FINAL

ENVIRONMENTAL IMPACT REPORT

RANCHO DEL REY SECTIONAL PLANNING AREA

LETTERS OF COMMENT
RANCHO DEL REY SPA II

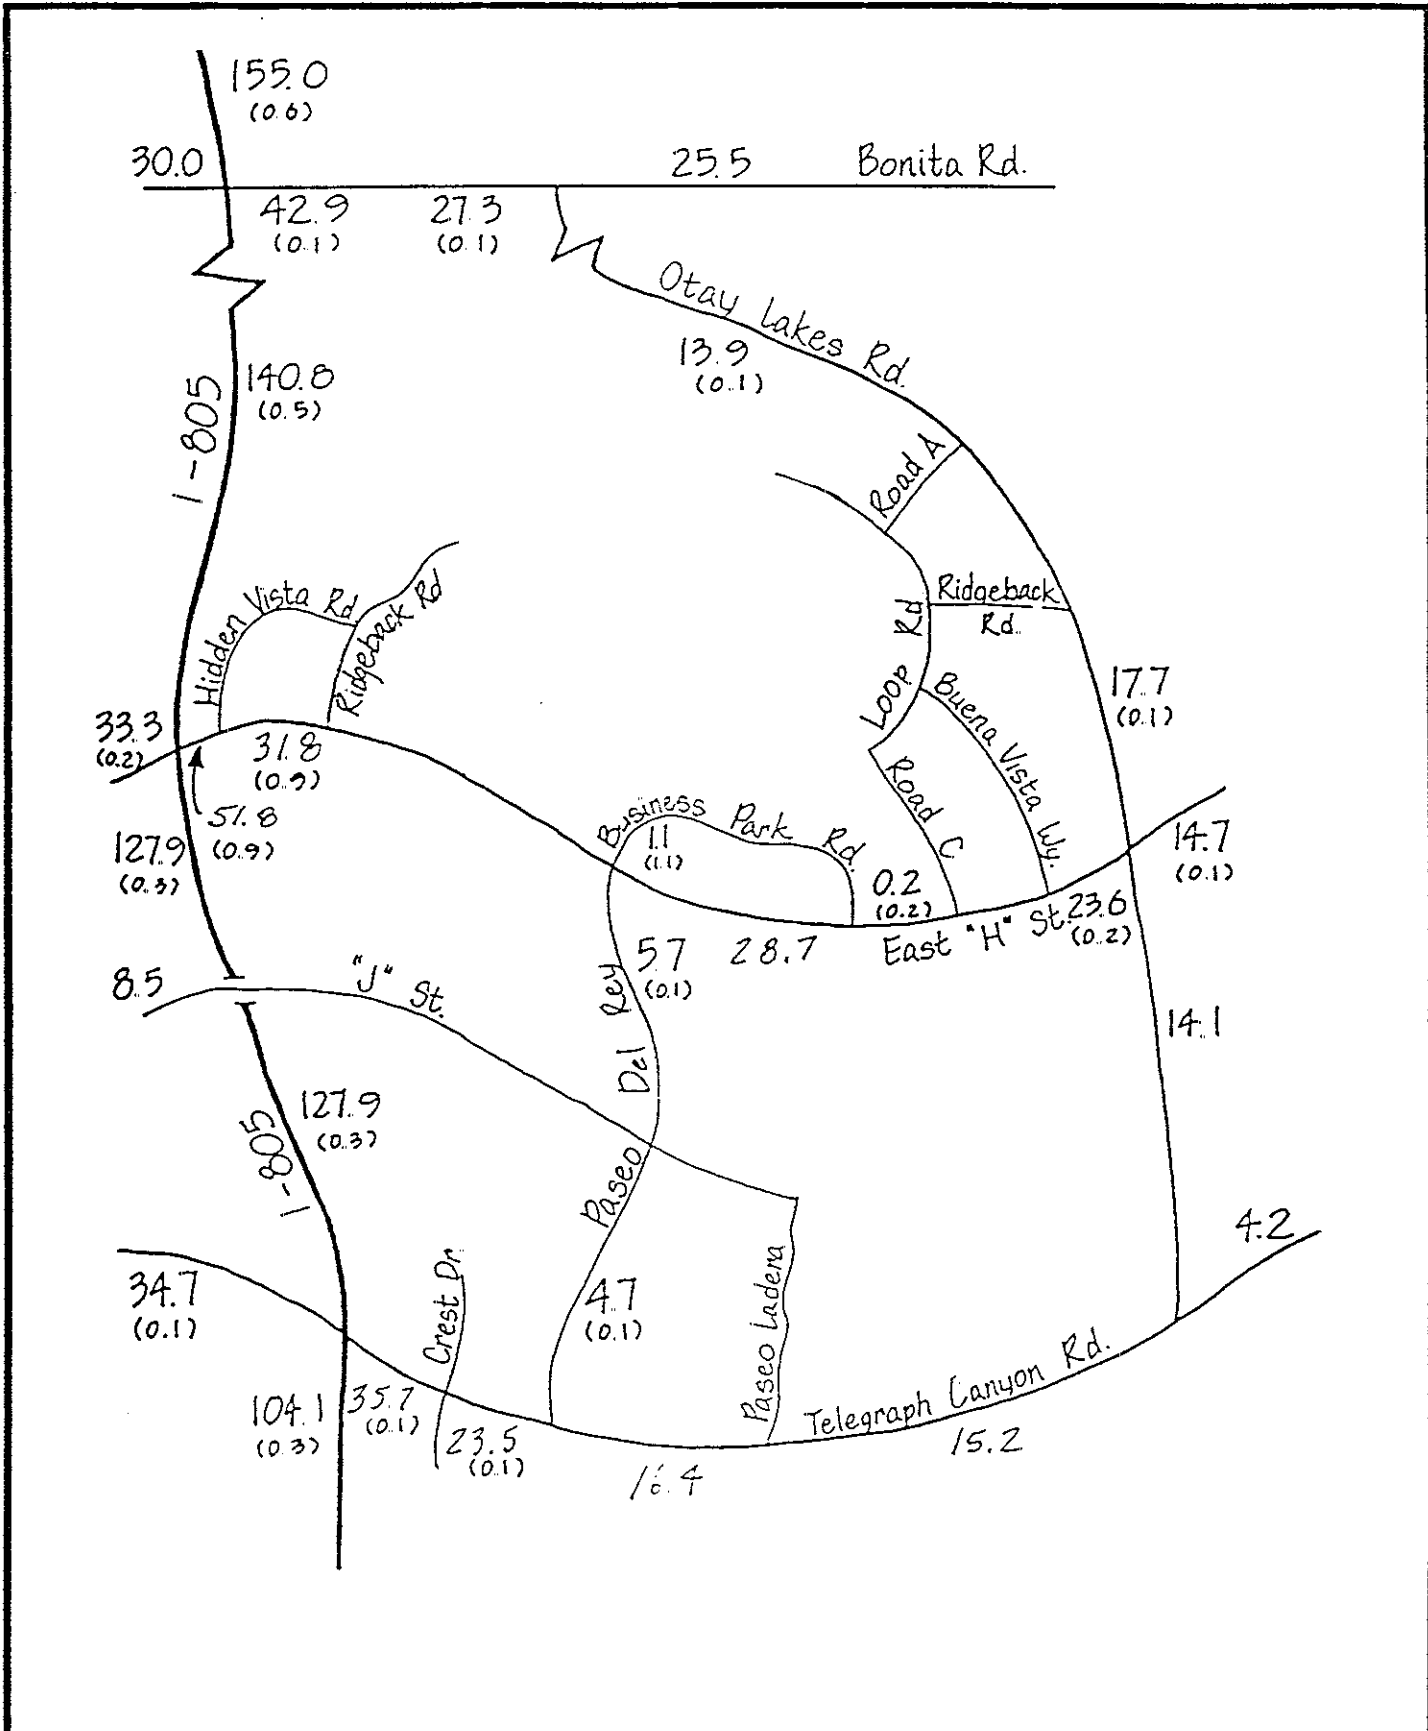
3. Section 3.6 - Transportation Access Figure 3-11 on page 55. There is a giant difference as to the existing traffic volumes shown in this table on the various street networks and the existing traffic volume shown on the same network in the Eastlake Greens EIR. This needs to be reconciled.

3. The difference in the data presented by the two reports is essentially due to the difference in dates when the two reports were compiled. Traffic data in the Rancho Del Rey SPA II report was collected by Bankston/Pine Associates in October 1988. Average (24 hours) weekday traffic levels were based on 1988 data collected by the City of Chula Vista. Traffic on I-805 was derived by adding 7 percent to 1987 CalTrans traffic counts. Traffic counts in certain areas were taken manually in May 1988 by a car counter company.

The traffic analysis for EastLake Greens was prepared by Willdan Associates and contained in a document dated April 1989. Traffic counts were provided from CalTrans (1988), the City of Chula Vista (1988) and SANDAG (1983-1987).
